Access Compliance Report Public Rights-of-Way (Curb Ramps)

Main Street: APPIAN_WAY Cross Street: MARBLE_ARCH_DR Location: N

ADA ID: RPRK211012181757 Ramp Type: Type 4 - Parallel Initial Pass/Fail: Fail Overall Compliance: No Severity Score: 15

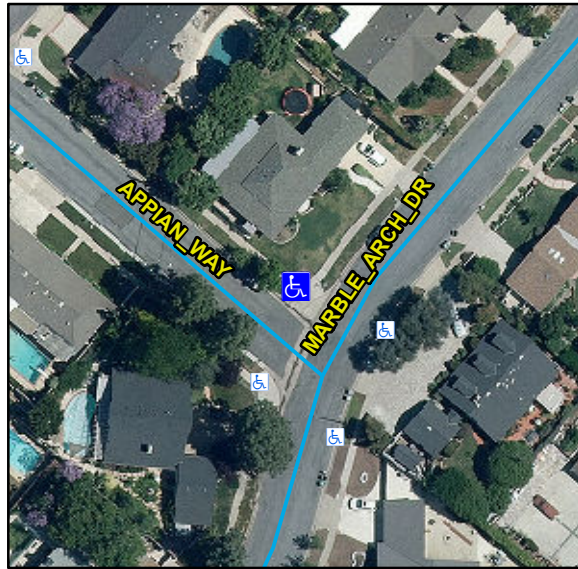
R304.2.2, R204.3, R304.5.3, STD 1115

Compliance	Description	Data	Compliance	Description	Data
N/A	Ramp Length LT (in)	128	N/A	Ramp Length RT (in)	128
Yes	Ramp Width LT (in)	132	Yes	Ramp Width RT (in)	134
Yes	Ramp Run Slope LT (%)	3.1	Yes	Ramp Run Slope RT (%)	2.8
No	Ramp Cross Slope LT (%)	5.6	No	Ramp Cross Slope RT (%)	5.9
N/A	Landing Present	N/A	N/A	DWS Provided	N/A
N/A	Landing Length (in)	N/A	N/A	DWS Contrast	N/A
N/A	Landing Width (in)	N/A	N/A	DWS Length (in)	N/A
N/A	Landing Run Slope (%)	N/A	N/A	DWS Full Width	N/A
N/A	Landing Cross Slope (%)	N/A		DWS Offset Type	N/A
N/A	Landing Movement Obstructed?	N/A	N/A	DWS Offset Left (in)	N/A
	Landing Movement Type	N/A	N/A	DWS Offset Right (in)	N/A
N/A	Landing Shared	N/A			
N/A	Clear Space	Yes			
N/A	Clear Space To Crosswalk (in)	N/A			
N/A	Marked Crosswalk 1	No	N/A	Marked Crosswalk 2	No
	Crossing 1 Direction	SW		Crossing 2 Direction	SE
	Marked Crosswalk 1 Width (in)	N/A		Marked Crosswalk 2 Width (in)	N/A

Remove & Replace Curb Ramp With Two New Directional Ramps or Equivalent.
